Planning, Zoning, and Building Department

BOARD ACTION REPORT – APPEALABLE ITEM

Project Name: Delray Ford
Project Location: 2501 South Federal Highway
Request: Class V Site Plan, Landscape Plan, and Architectural Elevations.

AGENDA ITEM: Delray Ford (File #2017-034) – Class V Site Plan, Landscape Plan and Architectural Elevations associated with the construction of a 50,662 square foot automobile dealership at 2501 Federal Highway.

SITE PLAN
DELRAY BEACH FORD
2501 SOUTH FEDERAL HIGHWAY
DELRAY BEACH, FLORIDA 33483

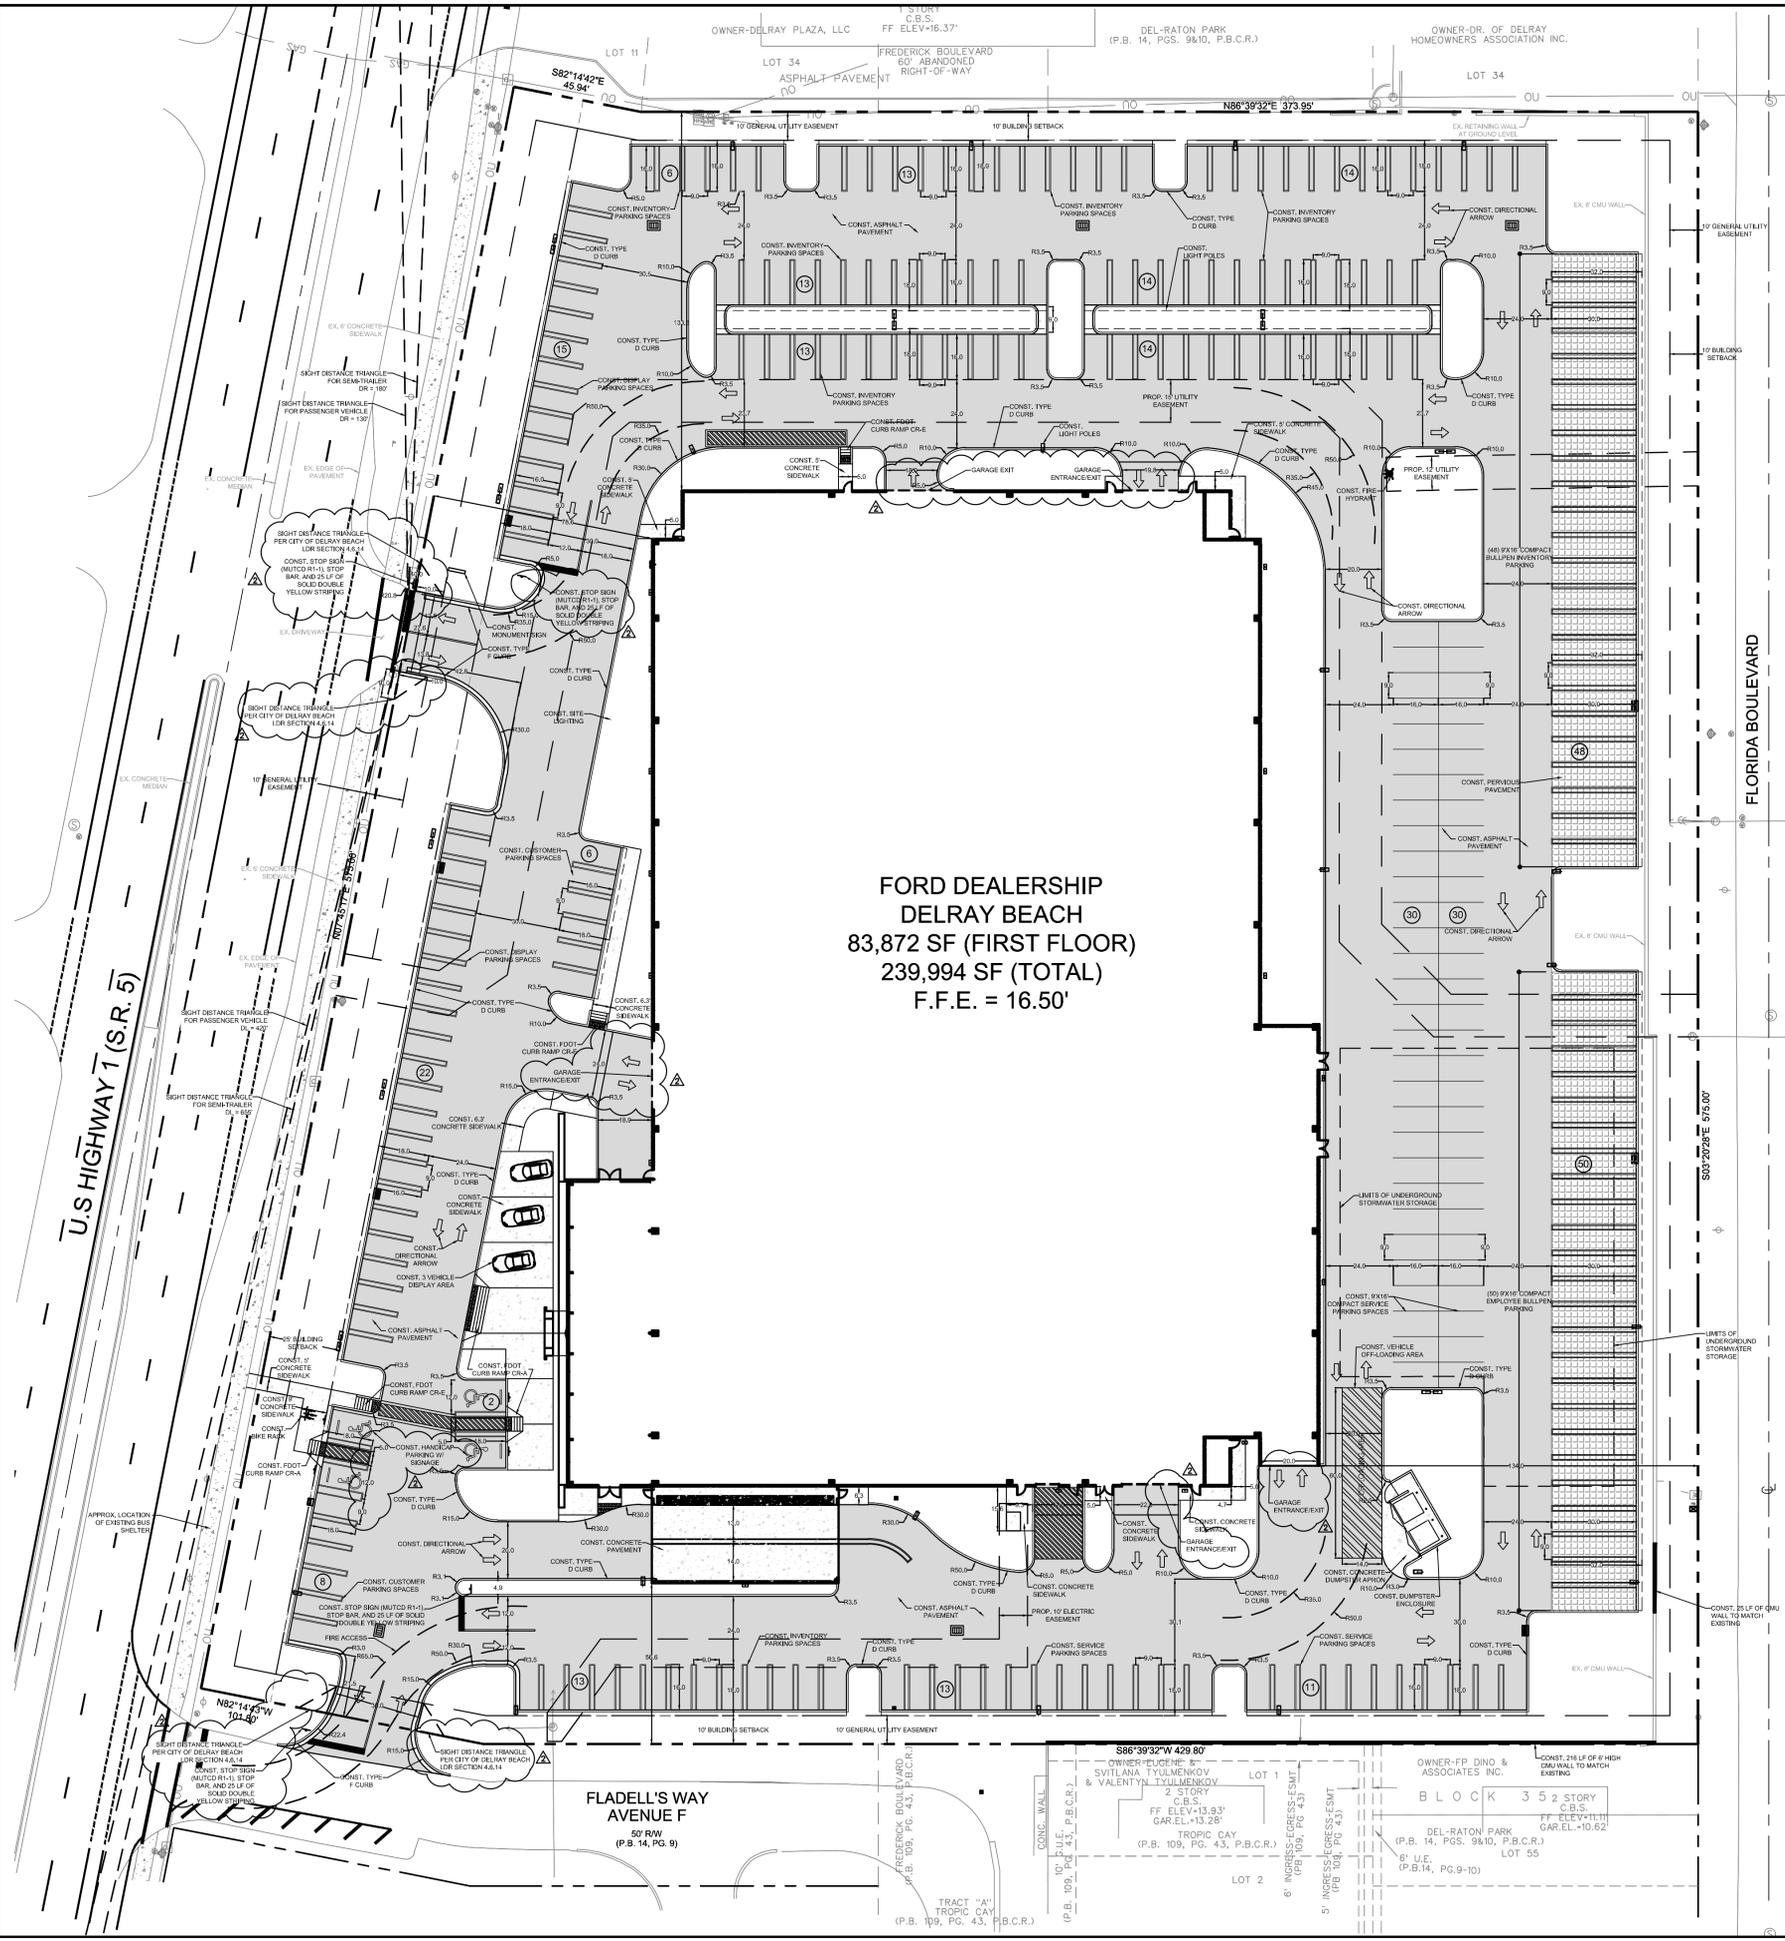
Off Street Loading: The applicant has provided one off-street loading space within the rear yard. The applicant has indicated the currently designated space will be shifted north, adjacent to the provided landscape island to comply with the 100-foot setback requirement from residential parcels. This relocation shall be a condition of approval until new plans are submitted that comply with this requirement. Furthermore, the applicant shall submit a "loading demand statement" as permitted by Sec. 4.6.10.C to request a reduction from the three (3) required berths to one (1) berth. The provision of this demand statement is listed as recommended condition of approval to be provided prior to site plan certification.

Landscape Islands: Per LDR Section 4.6.16(H)(3)(i), landscape islands which contain a minimum of 135 square feet of planting area, with a minimum dimension of 9 feet, exclusive of the required curb, shall be placed at intervals of no less than one landscaped island for every 13 standard parking spaces. One shade tree shall be planted in every island with a minimum of 75 square feet of shrubs and groundcovers. Tree specifications shall adhere to those listed in Section 4.6.16(E)(5) and 4.6.16(E)(6). Where approval for the use of compact parking has been approved, islands may be placed at intervals of no less than one 1 island for every 15 compact parking spaces. This landscape island is required for the display parking spaces along Federal Highway, where 22 and 15 parking spaces are provided in a row without the required landscape island. A condition of approval is attached that the plans be revised to provide the required interval of landscape islands and landscaping.

1. That a six foot masonry wall be provided along the northern property line, adjacent to the residential parcel;
2. That the dedicated off-loading area be relocated, in compliance with the residential setback;
3. That a loading demand study be submitted which justifies the reduced number of off-street loading areas;
4. That the overhead doors remain closed unless a vehicle is entering or exiting the structure;
5. That no outdoor loud speakers be permitted as part of this site plan approval, based on the proximity to residential developments;
6. That a portion of the 185 surface spaces (27 spaces) be reallocated for customer, employee, and/or service use to equal a minimum total of 152 spaces; and,
7. That a finding of concurrency be submitted from Palm Beach County Traffic Division prior to site plan certification.

Approve the Landscape Plan for Delray Ford located at 2501 South Federal Highway, based on positive findings with respect to Section 4.6.16 of the Land Development Regulations, subject to the condition that the plans be revised to provide the required interval of landscape islands and landscaping along Federal Highway.
